Illinois Tollway Standard Drawing Revisions
---

Section H	Roadway Lighting		
	Standard	Modification Summary	Effective: 03-01-2025
		This set of standard drawings has been converted from v8i to OpenRoads.	
	H1-13	LIGHT STANDARD FOUNDATION	
	Sheet 1	Added Note 12 indicating the soil conditions used for foundation design.	
	Sheet 3	Corrected d(E) bar length to provide appropriate concrete cover.	
	H7-04	EXTERIOR CONTROL CONSOLE FOUNDATION DETAIL	
	Sheet 2	Revised the type B control console foundation.

LIGHT STANDARD FOUNDATION

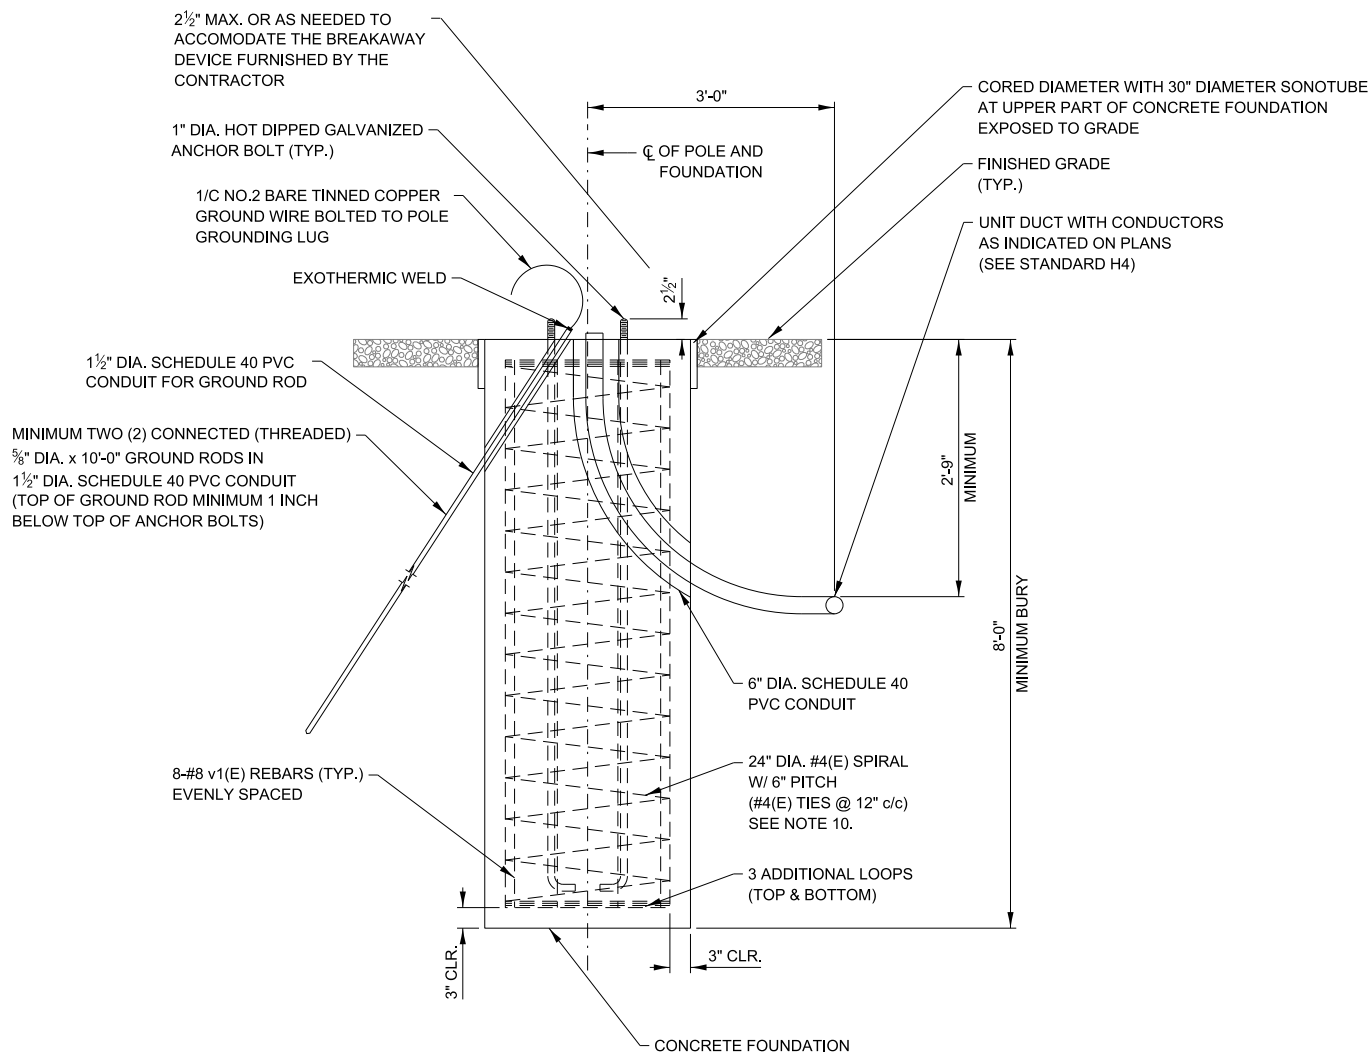
R E V I S I O N S	
DATE	DESCRIPTION
03-01-2025	ADDED DESIGN SOIL CONDITIONS NOTES, REV. d1(E) BAR LENGTH AND WEIGHT.
03-01-2024	REV. THE BOLT PROJ. DIM. FROM 3 1/2" TO 2 1/2". REV.DIM. OF THE MED. BARRIER, REV. ALL REF. TO AGG. FROM LVL. REV.
	GRADING DETAILS AND NOTES.

CONDUIT EMBEDDED IN BRIDGE PARAPET

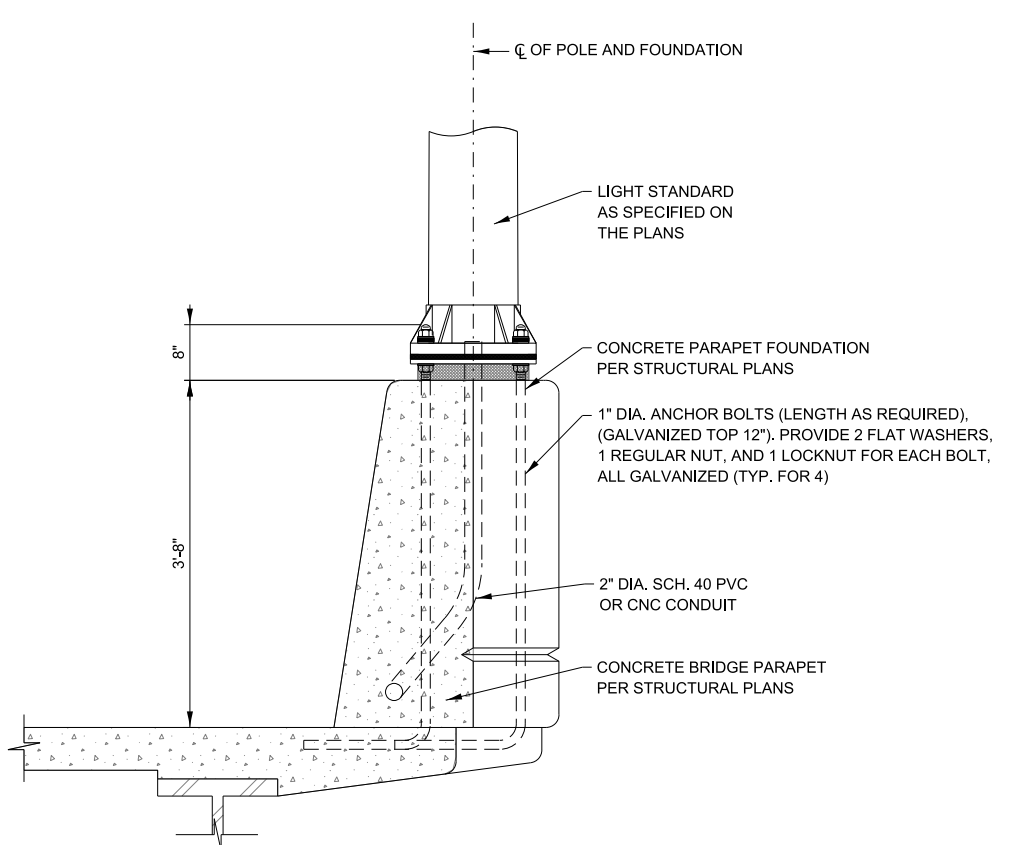
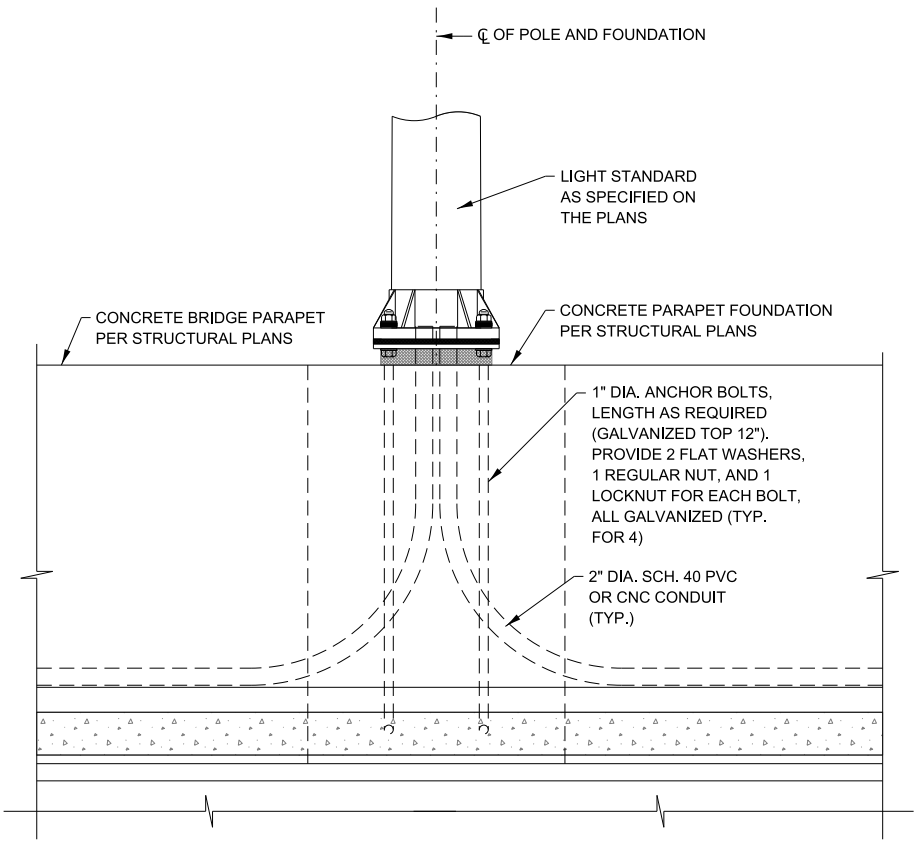
REVISIONS	
DATE	DESCRIPTION
03-01-2024	REMOVED THE DIMENSION OF THE ANCHOR BOLT FROM THE SECTION A-A VIEW. ADDED THE TRANSITION SLAB DETAIL. REVISED CALL-OUTS FOR SECTION A-A VIEW. REVISED CALL-OUTS TO THE ELEVATION VIEW.

EXTERIOR CONTROL CONSOLE FOUNDATION DETAILS

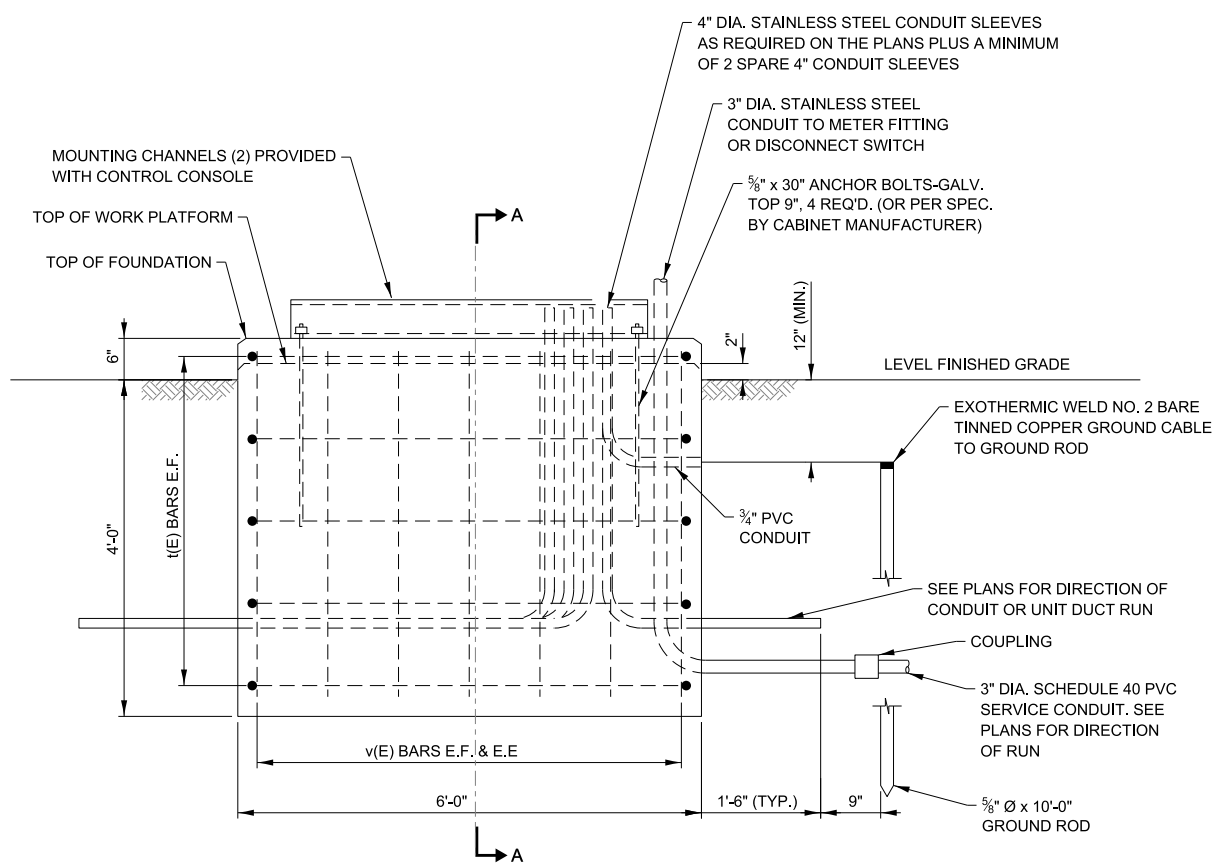
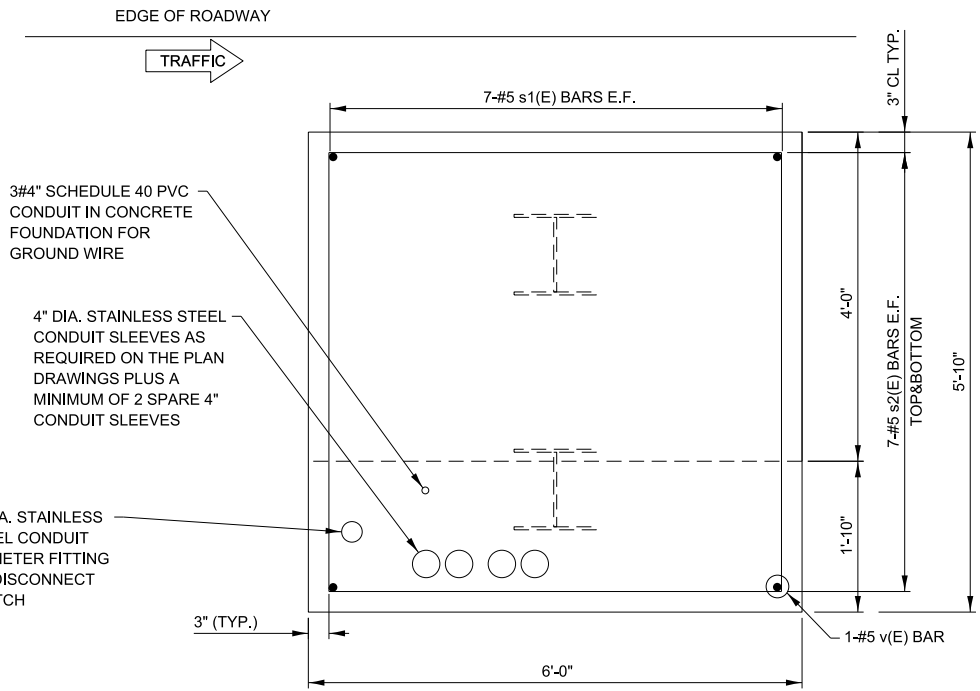
REVISIONS	
DATE	DESCRIPTION
03-01-2025	UPDATED FOUNDATION DESIGN.
03-04-2019	REVISED CONDUITS TO MATCH H5.
03-11-2015	REVISED CONDUITS TO STAINLESS STEEL.
02-07-2012	REVISED TYPE A AND TYPE B
	CONTROL CONSOLE FOUNDATIONS.

8. FOR TYPE B FOUNDATION REINFORCEMENT, WELDED WIRE MESH 6X6 DI6, Fy=60 KSI CAN BE USED.

PARKING LOT LIGHT  
FOUNDATION DETAILS

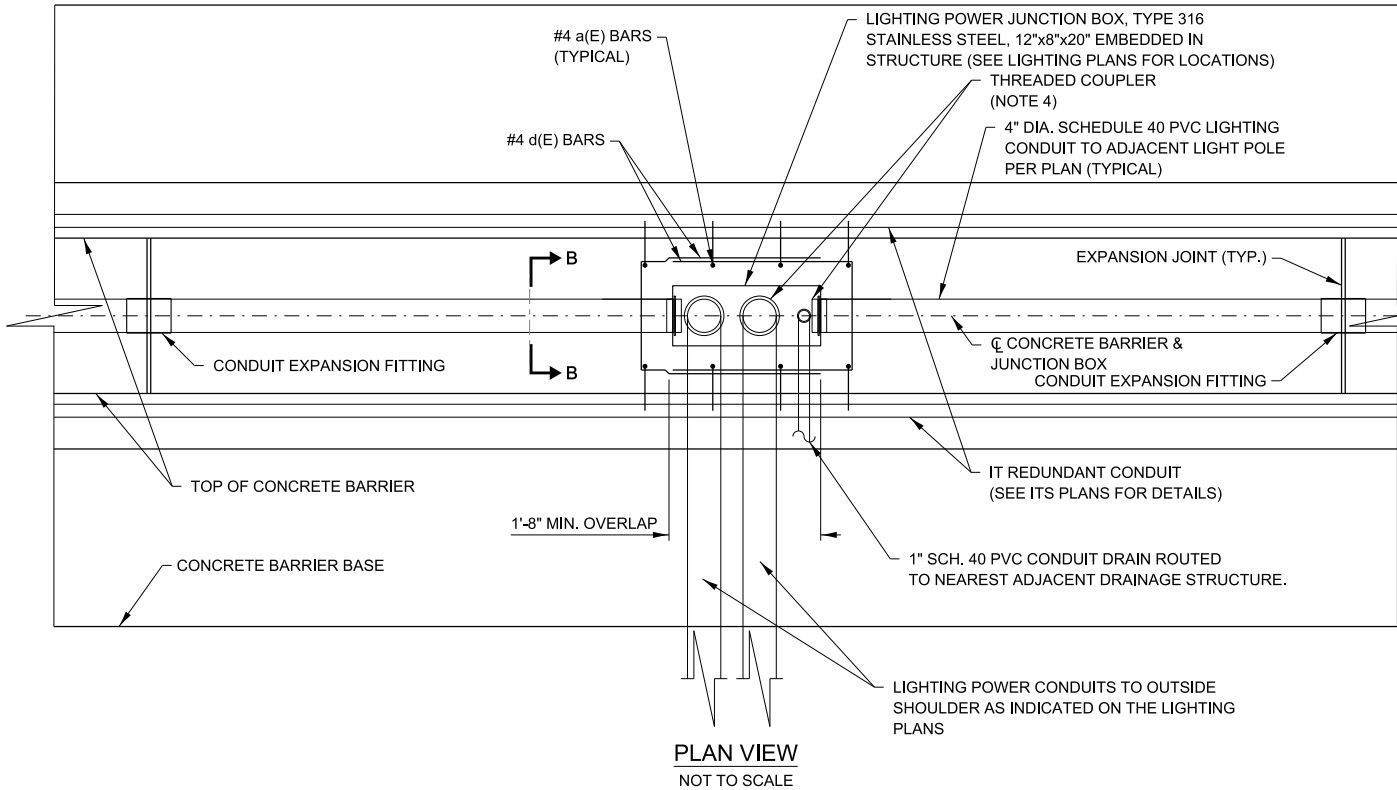
REVISIONS	
DATE	DESCRIPTION
03-01-2023	REVISED v1(E) BARS FROM #6 TO #8
03-01-2022	INCREASED ANCHOR BOLT PROJECTION
